With reference to his letter dated 3rd Instant with an amended plan for the proposed additions in water closet and bath block in the building under construction on plot No. 6/1.F-15 Sadar Bazar Quarter Mr. Shamdas Kodanmal is informed the same is approved and permission to proceed with work in accordance therewith is hereby granted.

KMR.CDD.SaQ.1919-1921.01

I beg to submit herewith amended
plan of Sheet F.15. Saddar Bazar quarter.

Amened plan
Building on plot- No 6/ Sheet F 15
Subber Bazar Quarter
Scale 8"=1"

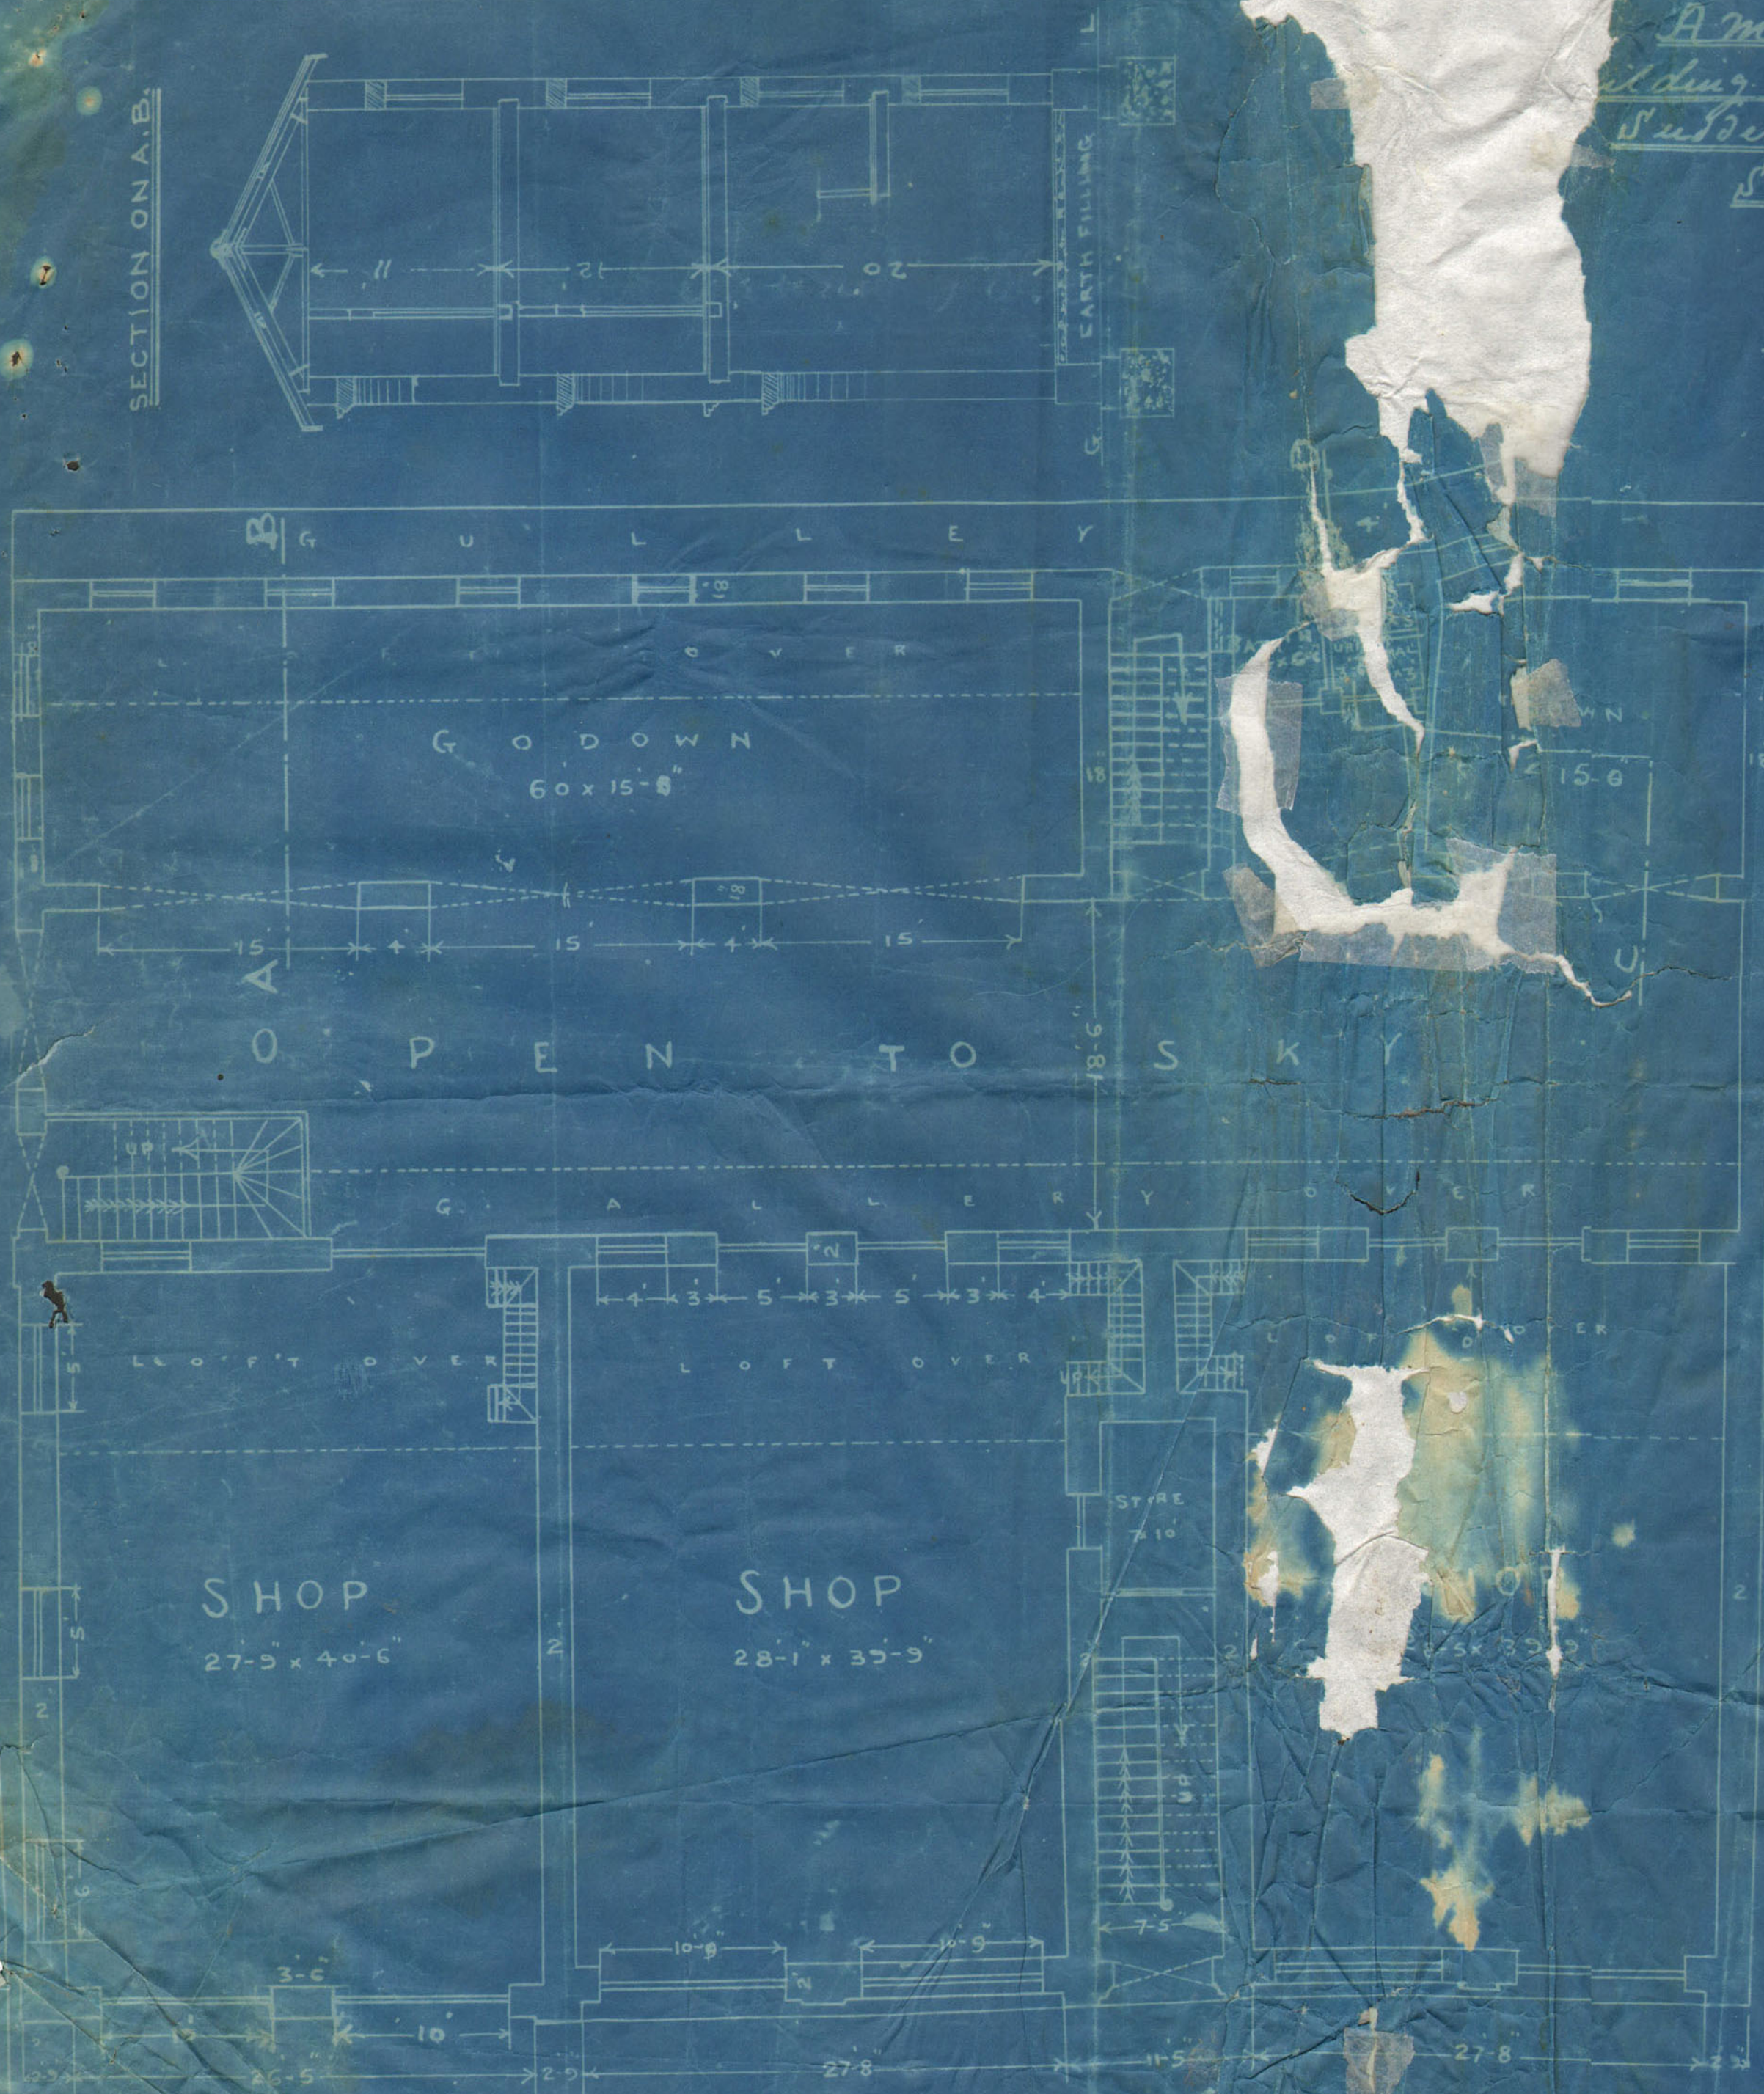
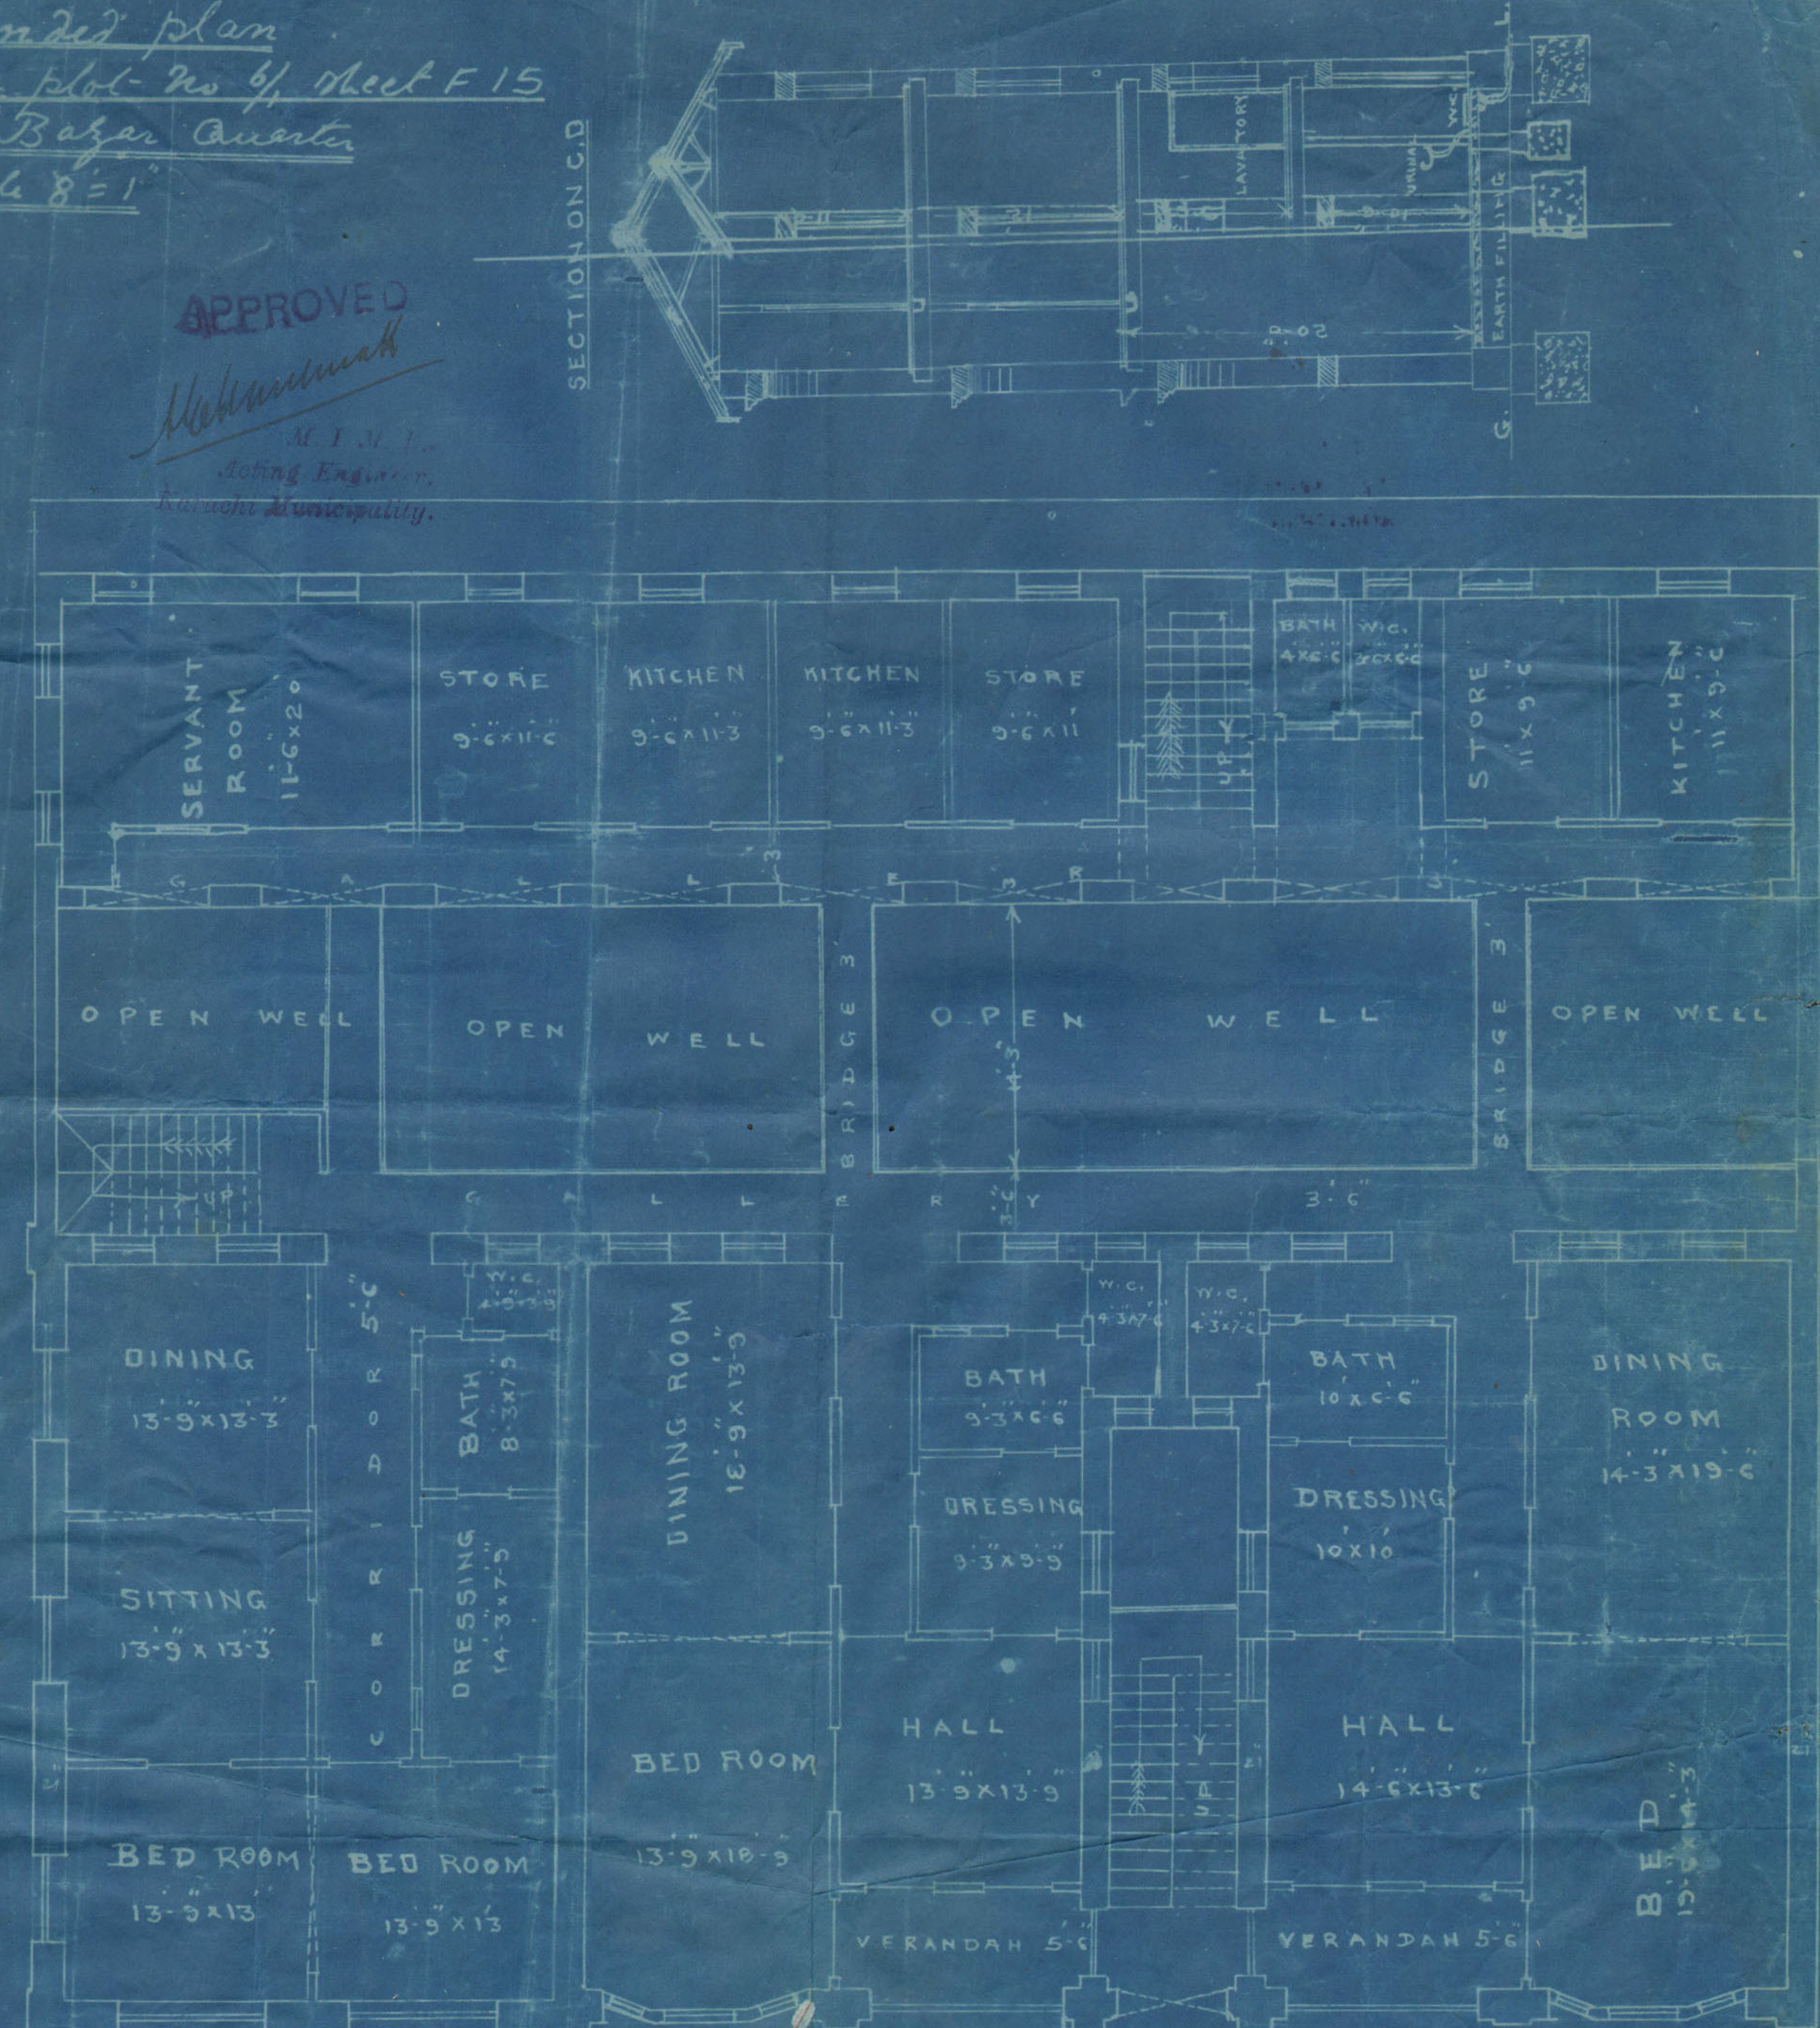
The amendments are slight and chiefly
due to my desire to make the thin walls
of servants W.C. & bath thick viz of stone
instead of wood & plaster.

Submitted with the report
 the applicant wants to make
 the front wall of W.C. & bath
 pucker, & by this arrange-
 ment to away with the
 6x6' air space and provide

2 sets of sanitary arrange-
 ments between the ground
 floor & 1st floor. The height of 1st floor is 20 ft.

The rear wall of W.C. is
 already of stone masonry
 & there was no necessity of
 showing it in red.

As the W.C. is not contrary
 to bye laws & there is much
 open space left on the plot
 there appears no objection
 to allow the same.

Submitted for order. There
 appears no objection to approve.

APPROVED
